***Re: MODIFICATION NO: 2012/195/2***

***St John's Anglican Church Precinct, Camden***

***APPROVED DEVELOPMENT: Alterations and extensions to the existing church hall, its use as a place of public worship and associated site works***

***PROPOSED MODIFICATION: Section 4.55(2) Modification – Design modifications to approved church hall alterations and extensions, extended operating hours and tree removal***

*Source: NBRS Architectural Plans (p. 15) Internal view*

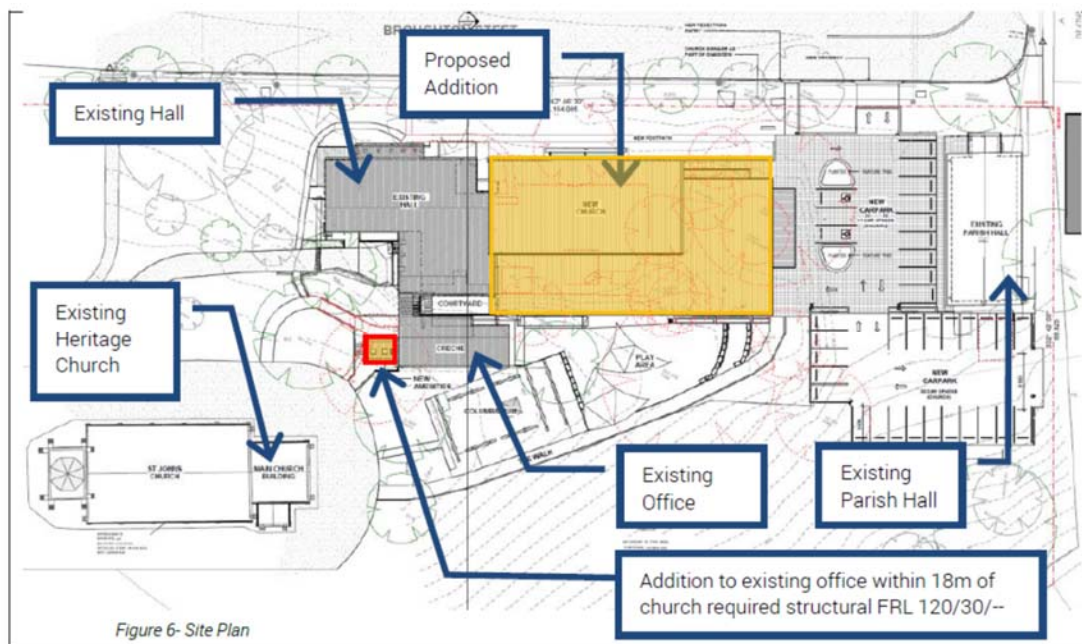
Artist's impression (p. 15) above depicts:

*Source: NBRs Architecture BCA & DDA/Access Compliance Review (p. 11)*

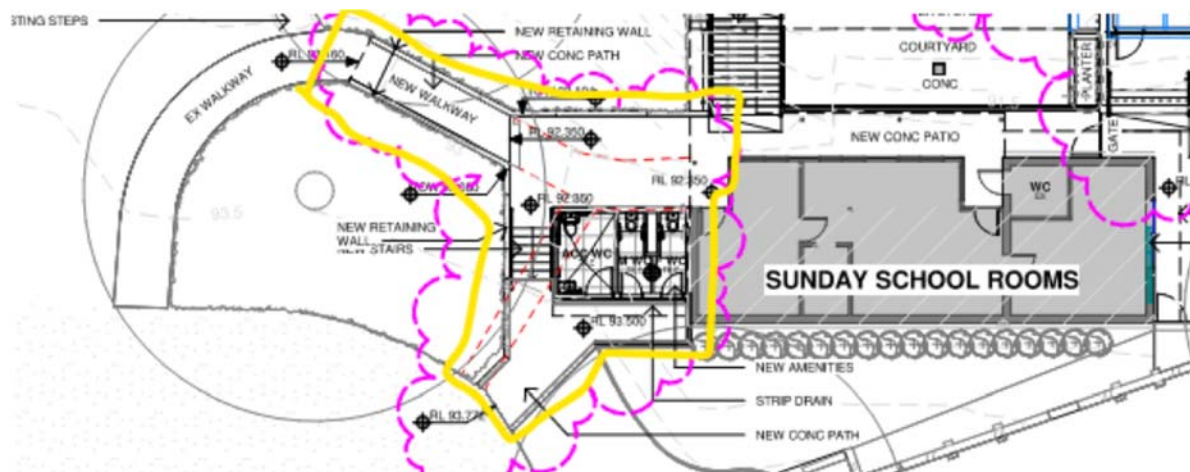
The site plan below depicts the increased development of the Precinct including a new toilet block marked in red which has doors at grade to the south facing the columbarium, but is otherwise higher than the adjacent building.

We also objected about the staging of this toilet block under 2 *d. Funding timeframe and “staged” toilet block.*

It should not be “staged” within this DA modification but be subject to full and independent analysis and assessment.

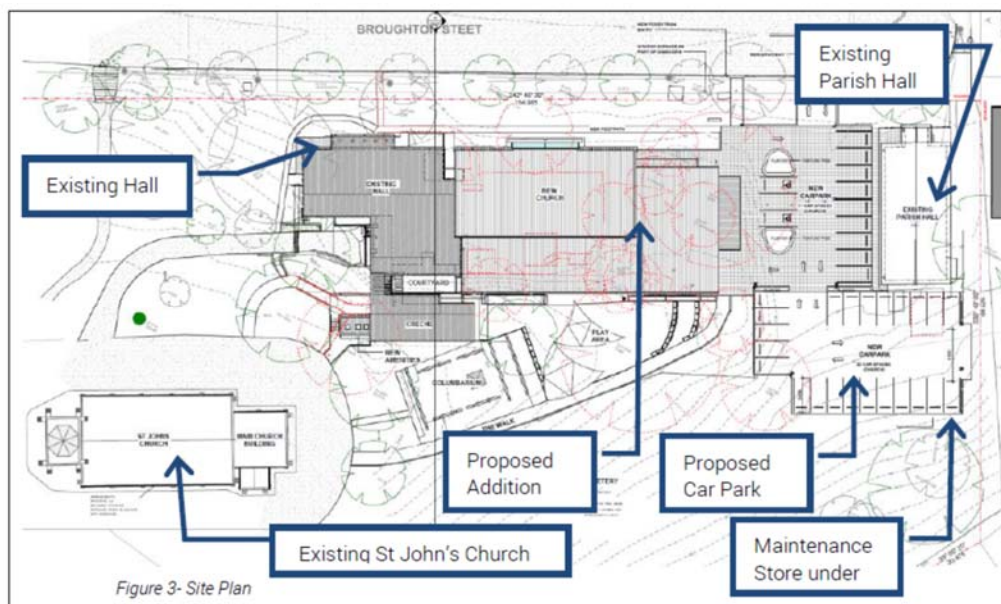
The path through the Precinct is too close to the cemetery. The layout shows lack of respectful surrounding quiet space and respectful access to it.

Similarly, there is a lack of respectful and dignified quiet space surrounding the columbarium. The proposed toilet block doors open to it. The children’s playground is too close.
